TRANSMITTAL FORM

Date: **March 19, 2001**
Project Number: **556-2912-01(03A)**
Project Name: **POS-Master Plan Update**

Re: Port of Seattle, Ref. No. 1996-4-02325

Sheldon & Associates, Inc. has been retained on the behalf of the Airport Communities Coalition to conduct reviews of environmental documents submitted by the Port of Seattle for the proposed Third Runway project at the Seattle-Tacoma International Airport (STIA) focused on the proposals to minimize hydrologic impacts to the wetlands left on the site, and to the proposed compensation plan within the upper Miller Creek drainage. Given the extent of questions remaining on the analysis of the proposed impacts of the project, I have precluded reviewing or commenting on the proposed off-site compensation project in Auburn as it appears premature to completion of the impact assessment.

Figure 1. Functional rankings assigned to wetlands being eliminated for the Third Runway Project.

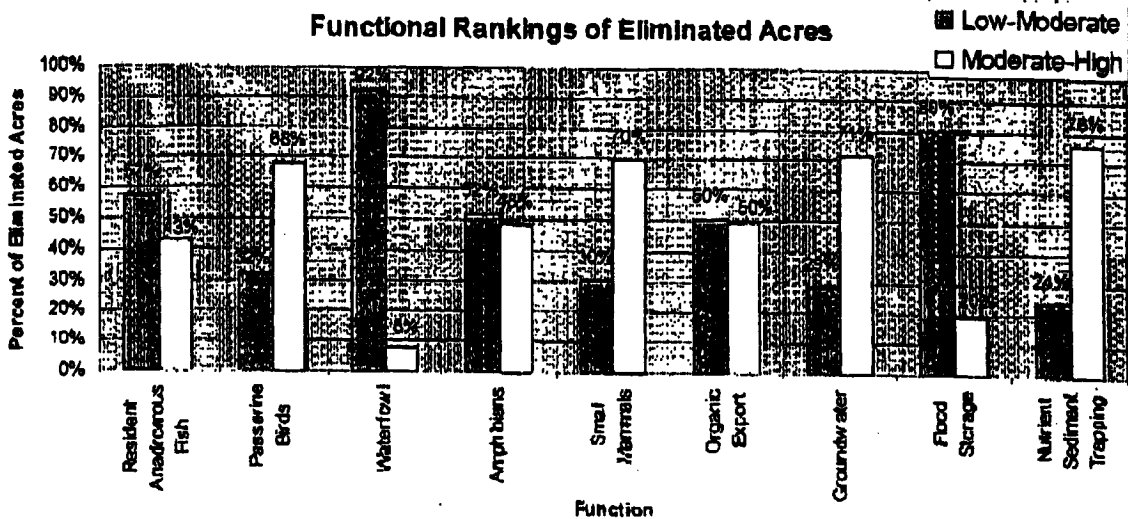
8
 Figure 1 shows that the highest-ranking functions being eliminated from the watershed in the greatest proportion are habitat for passerine birds (68%), small mammals (70%), groundwater discharge/recharge (71%), and nutrient sediment trapping (76%). Forty-three percent of the wetland acres being eliminated are ranked moderate-to-high for anadromous fish habitat, forty-eight percent are ranked moderate-to-high for providing amphibian habitat, and fifty percent are highly valued for export of organic material.

9
 Significantly, 92 percent of the eliminated wetlands are low-to-moderate for waterfowl habitat, and 80 percent are low-to-moderate for flood storage. These are proportionally the lowest-ranking functions among all the wetlands being eliminated, yet waterfowl habitat and flood storage are the primary functions targeted for replacement in the NRMP.² The grossly misplaced emphasis makes no environmental sense at all and serves to create the impression of mitigation where no effective mitigation in fact exists. The mitigation proposal appears to be tailored to the needs of the project rather than the requirements of the Clean Water Act.

Figure 2. Department of Ecology (DOE) ratings for wetland acres eliminated.⁴

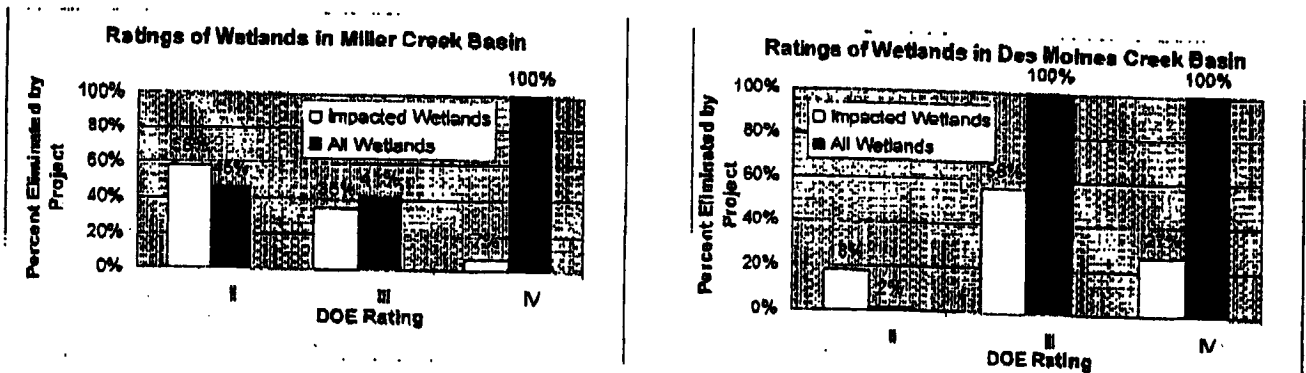
10
 Figure 2 shows the ratings of wetlands in the Miller and Des Moines Creek watersheds, using Department of Ecology's (DOE) Wetland Rating System. Starting at the left of each chart in Figure 2, the first bar shows the proportion of wetlands being eliminated for each of the three pertinent DOE ratings. The second bar shows the percent of wetland acres in the Port's entire project area that have that rating and are being eliminated. For example, the Miller Creek Basin chart in Figure 2 shows that 58 percent of the wetlands eliminated by the Third Runway in the Miller Creek watershed are rated Class II. It also shows that 45 percent of all the Class II wetlands identified within the Miller Creek Basin project area will be eliminated.³

11
 The bar charts in Figure 2 illustrate that the majority of wetland acres being eliminated for the Third Runway project in the Miller Creek watershed are more highly rated Class II wetlands, rather than lower quality Class III and IV wetlands. This evidence directly contradicts the repeated statements

11. made in the NRMP and Wetland Functional Assessment that the wetlands to be eliminated are degraded to the extent that they provide few valuable functions.⁵

10. Commentor's Figure 2 does not present new information on the scope of wetland impacts. The *Natural Resource Mitigation Plan* Table 3.1-2 shows the relative impacts to Class II, III and IV wetlands from the project. This table illustrates that in the Miller Creek basin 14.37 acres of wetlands will be impacted, and that 8.37 acres (58%) of this area is Class II wetlands, 5.03 acres (35%) is Class III and 0.97 acres (7%) is Class IV.

Figure 3. Proportion of wetland habitats eliminated.

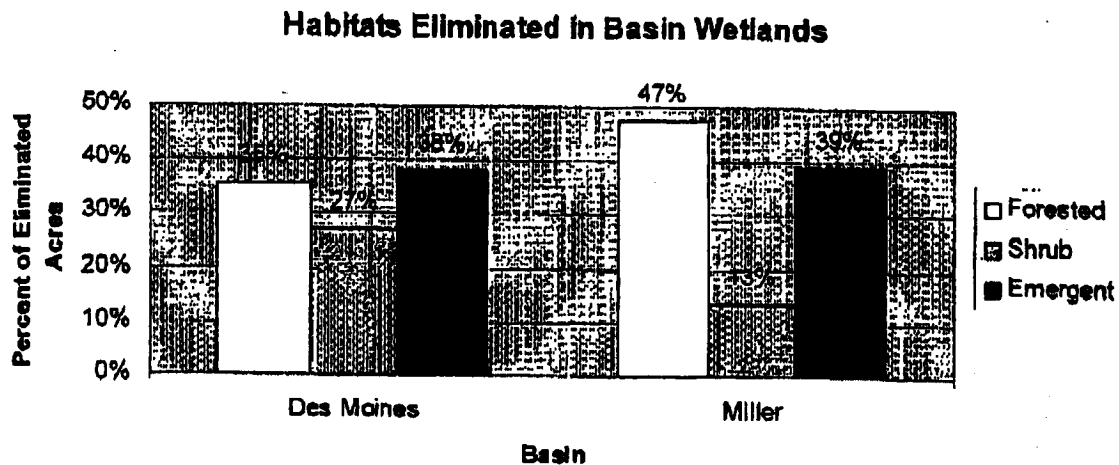
12. Another important measure of wetland function is proportion of habitat types, such as emergent, scrub-shrub, or forested wetlands. Figure 3, below, identifies the types of habitat that will be eliminated in the Miller Creek and Des Moines watersheds. The charts show that the majority of wetland acres to be eliminated in Miller Creek are forested wetlands, followed by emergent habitats. Shrub wetlands constitute the smallest component of habitat types being eliminated.

13. Based on the results revealed in Figures 1, 2 and 3, commensurate mitigation for these lost functions would require replacement of habitat for passerine birds, small mammals, and amphibians. It would require assurances that the sediment and nutrient trapping functions be compensated for, as well as groundwater exchange functions. To comply with Section 404 Guidelines, a plan would have to ensure that sources of organic export within the affected watersheds be maintained and that there be no net loss of fisheries habitat (resident or otherwise), particularly in light of recent and proposed Environmental Species Act (ESA) listings. An acceptable plan would include creation of wetlands rated Class II or greater and would provide habitat dominated by forested and emergent wetland systems.
